SECTION 009113 – ADDENDUM ONE

- A. Project Name: 22034.02 Meridian High School Additions, Renovations and Ballfield Rebid
- B. Owner: Meridian Public School District, 1019 25th Avenue, Meridian, MS 38391
- C. Architect: Dale | Bailey, an Association, One Jackson Place, Suite 250, 188 East Capitol Street, Jackson, MS 39201-2100
- D. Architect Project Number: 22034.02
- E. Date of Addendum One: 5 January 2024

1.4 REVISIONS TO DRAWINGS

S-402

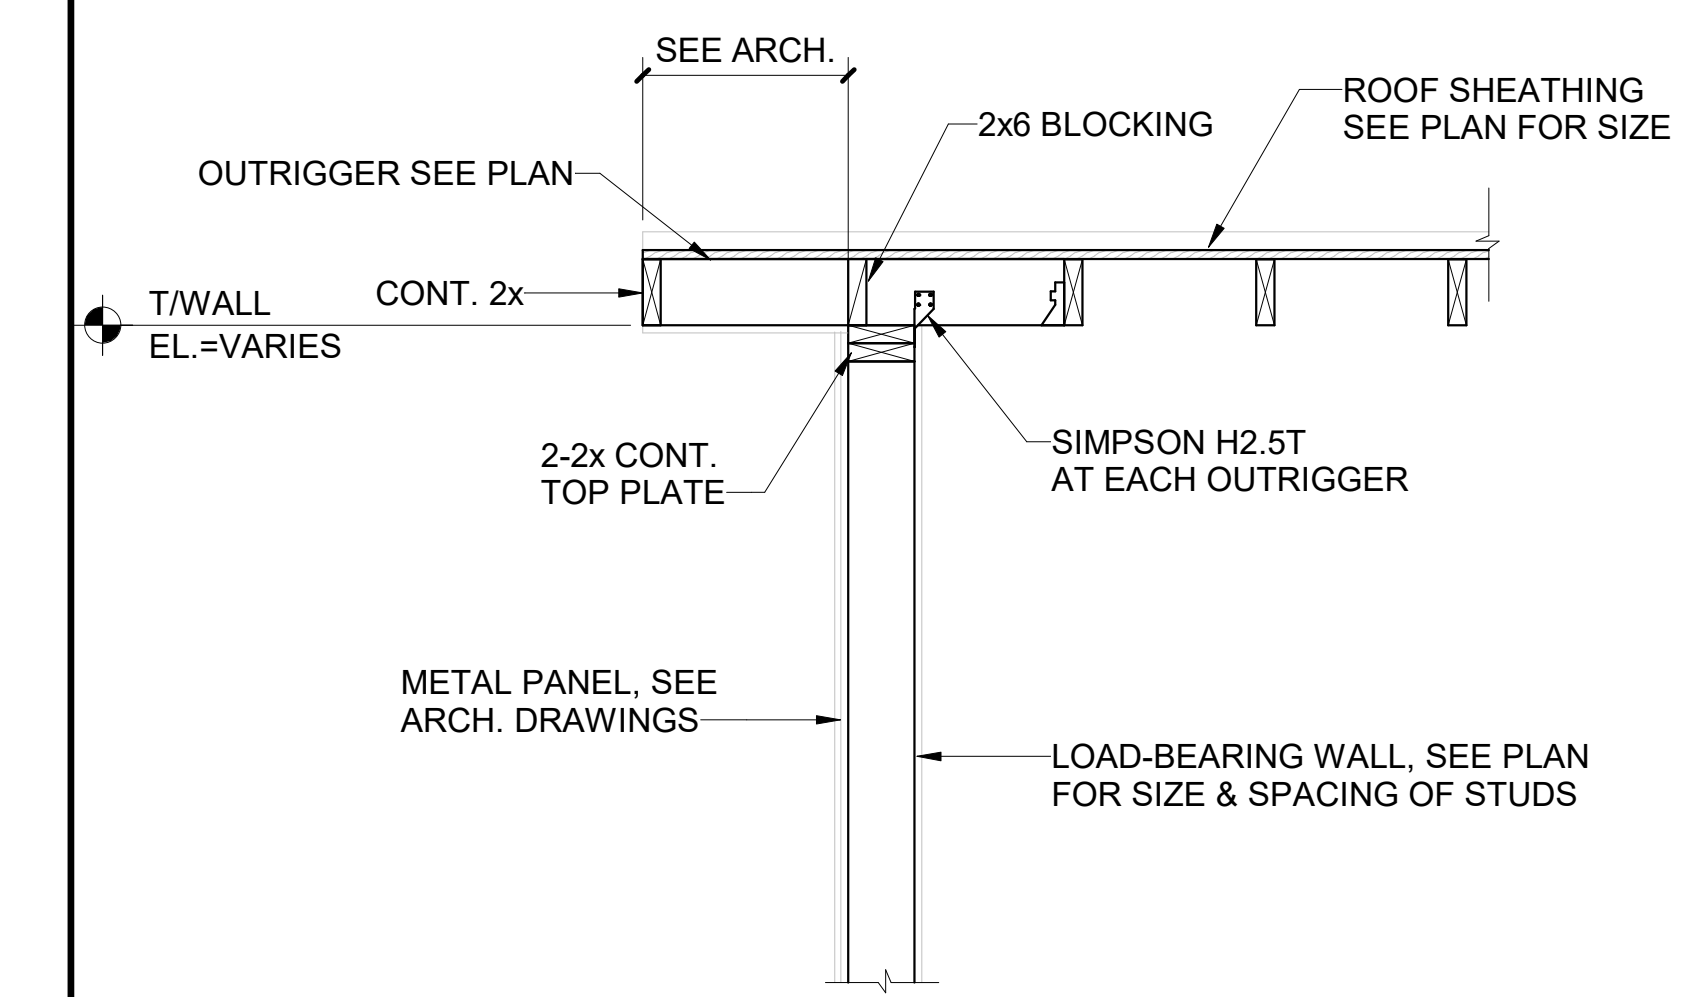
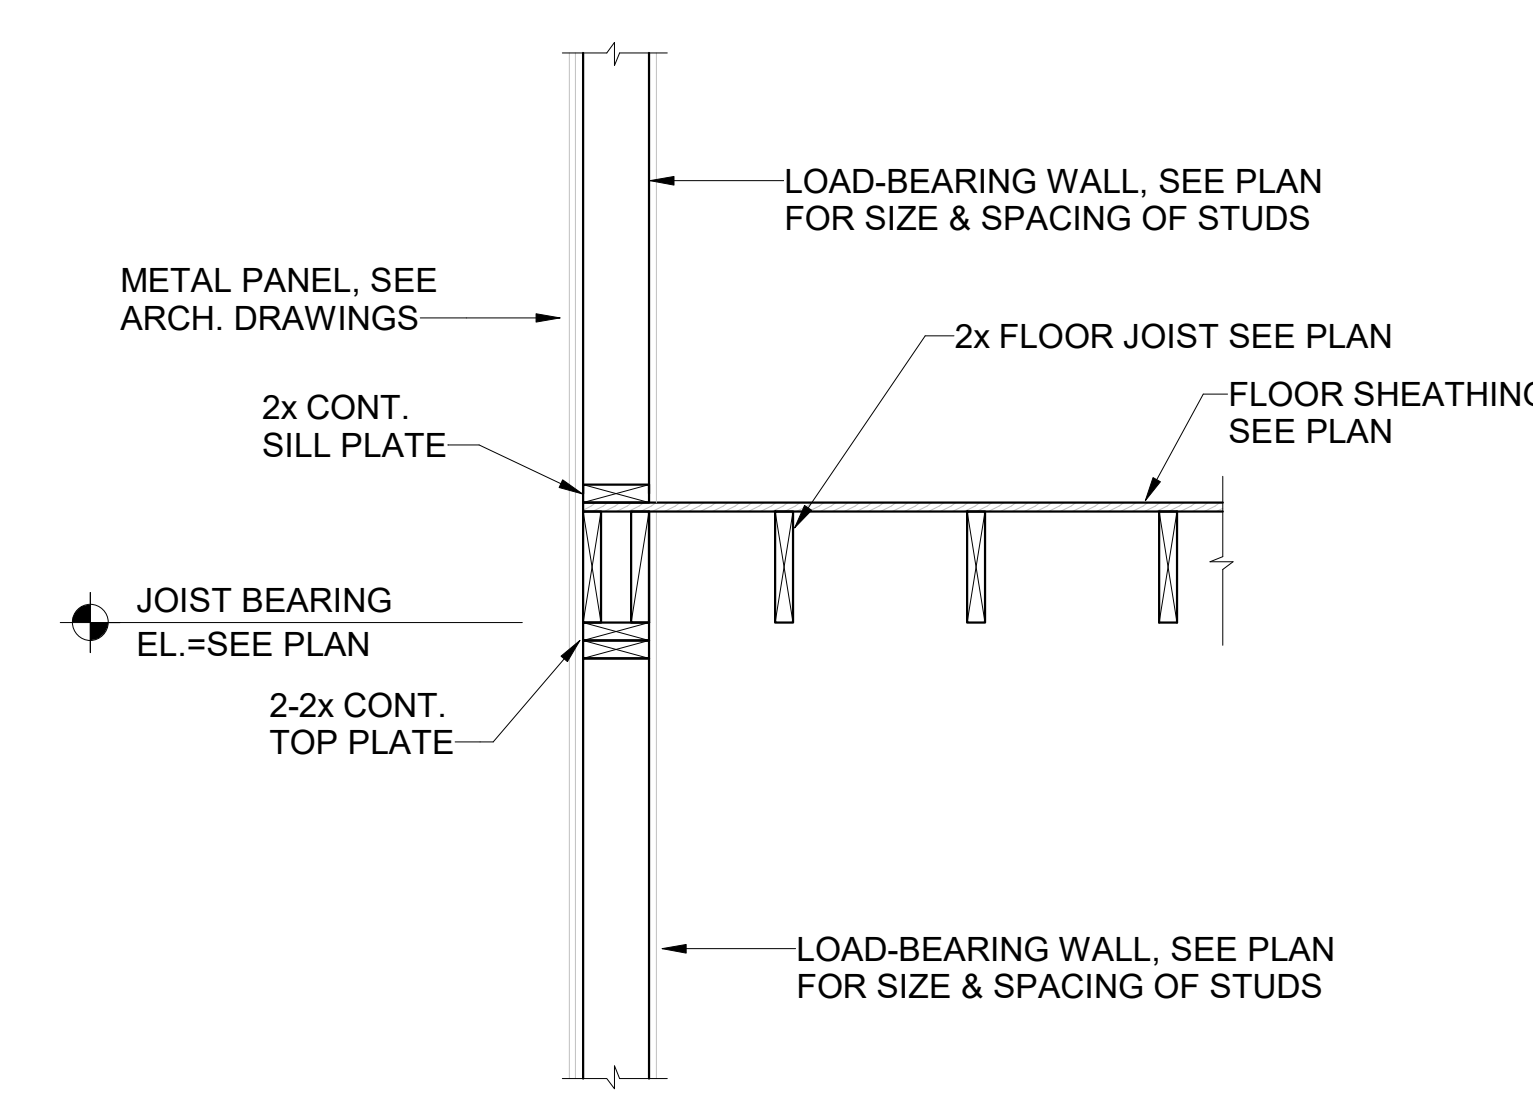
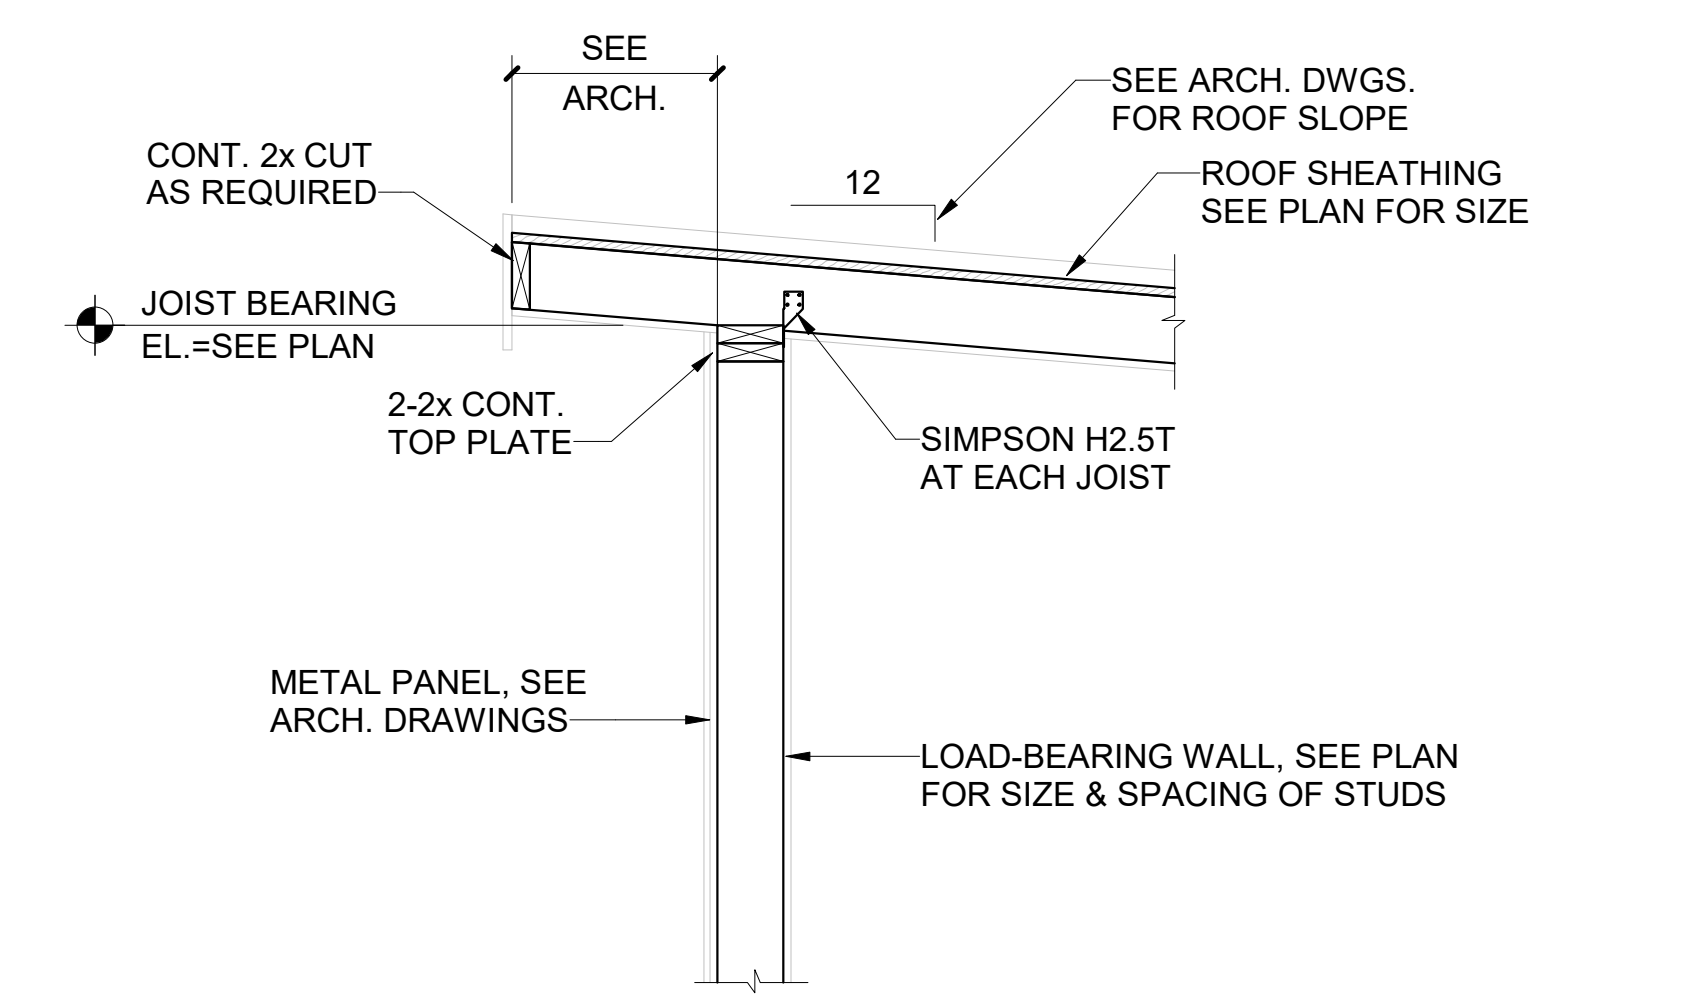
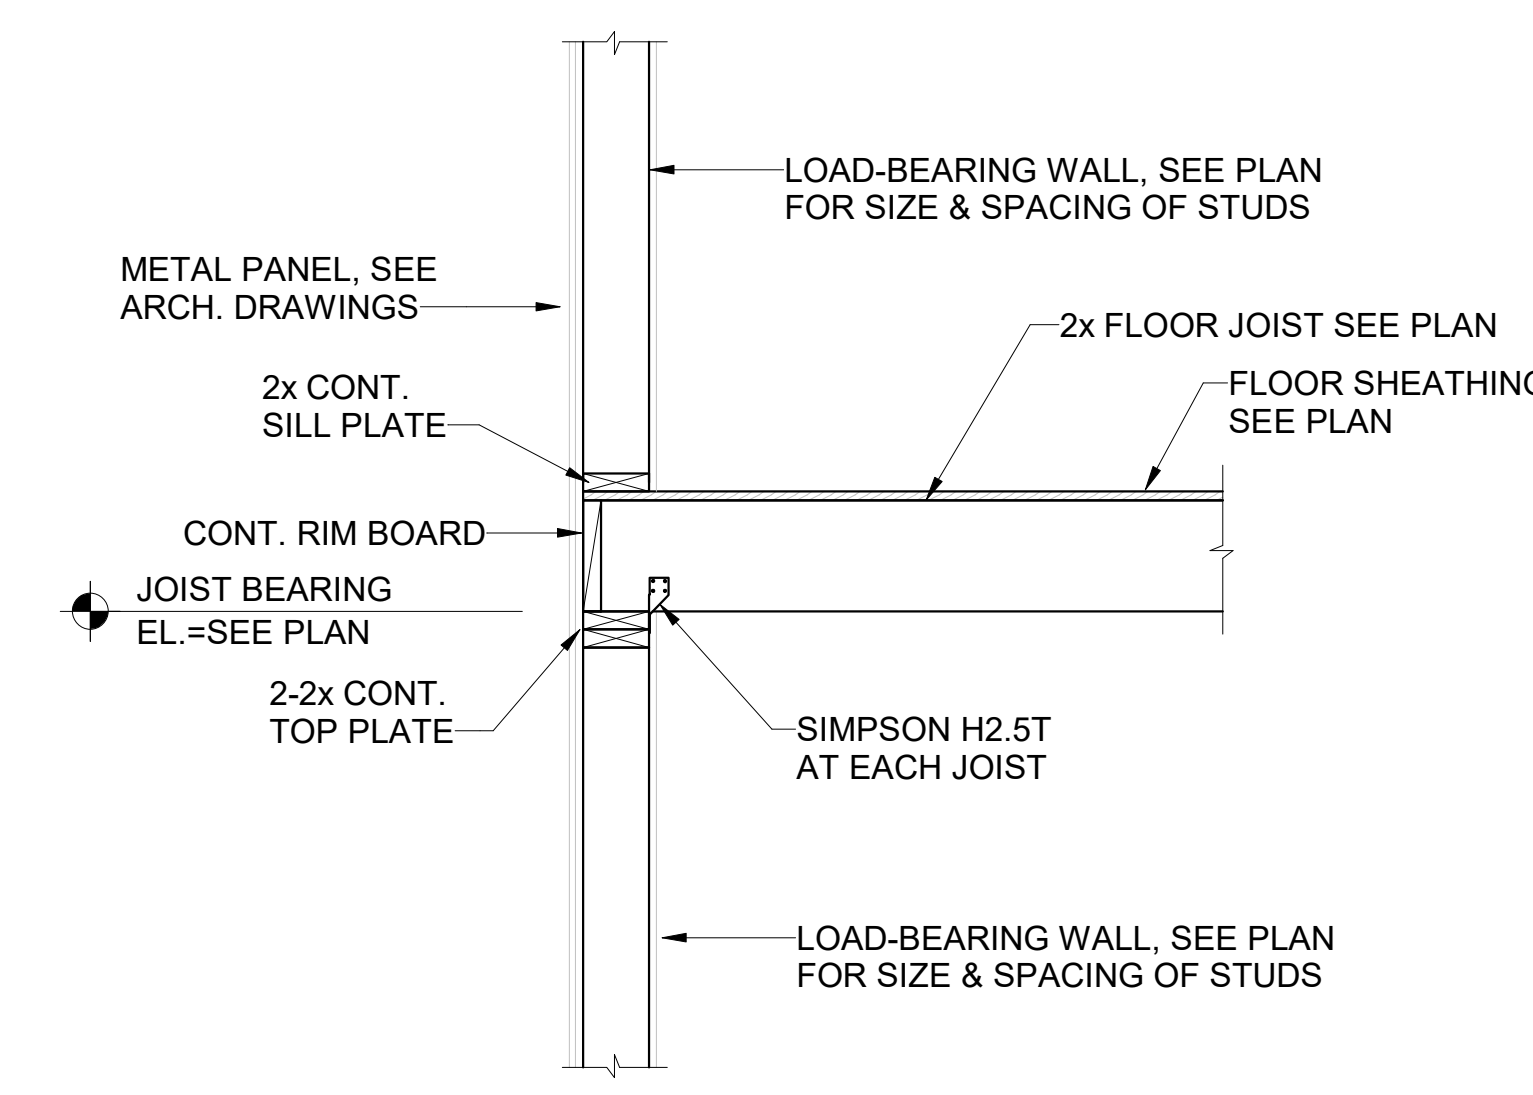
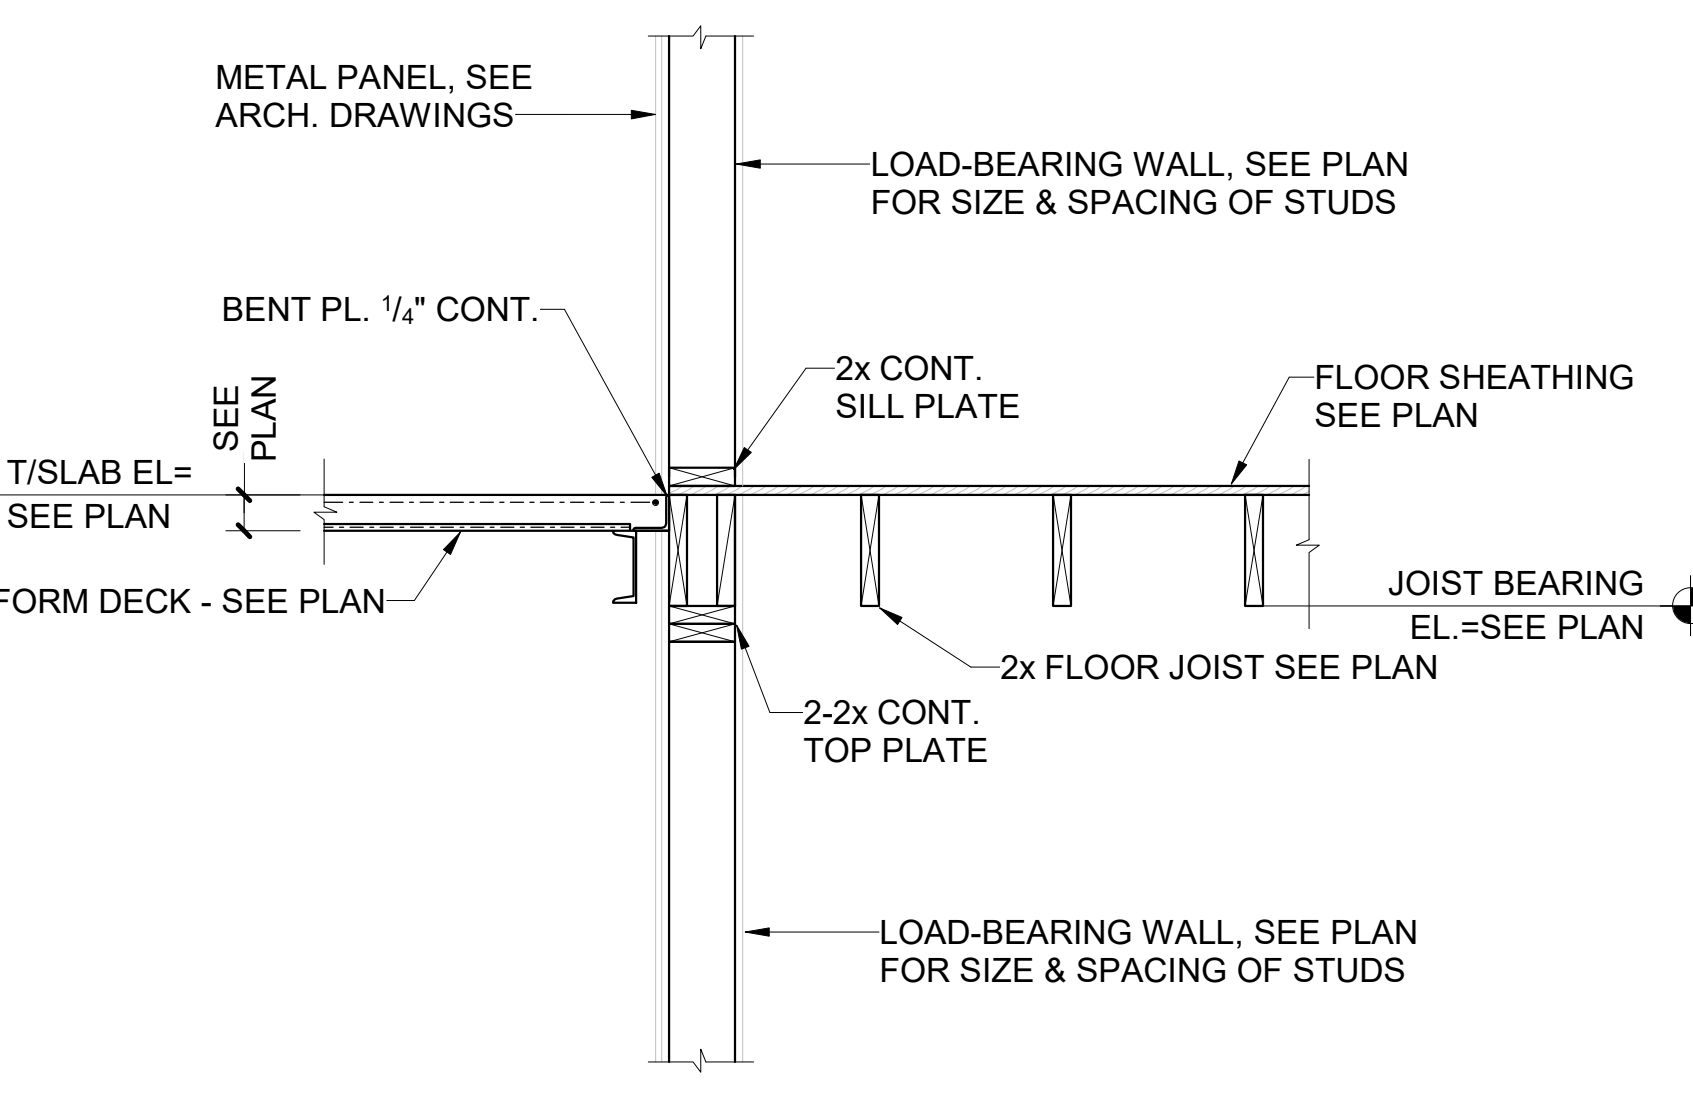
- E. Sheet S-402 (Revised). Updated detail at edge of pressbox and ramp
- F. Sheet S-403 (Revised). New details for pressbox ramp.
- G. Sheet C-200 (Revised). Updated to reflected additional demo items at baseball area
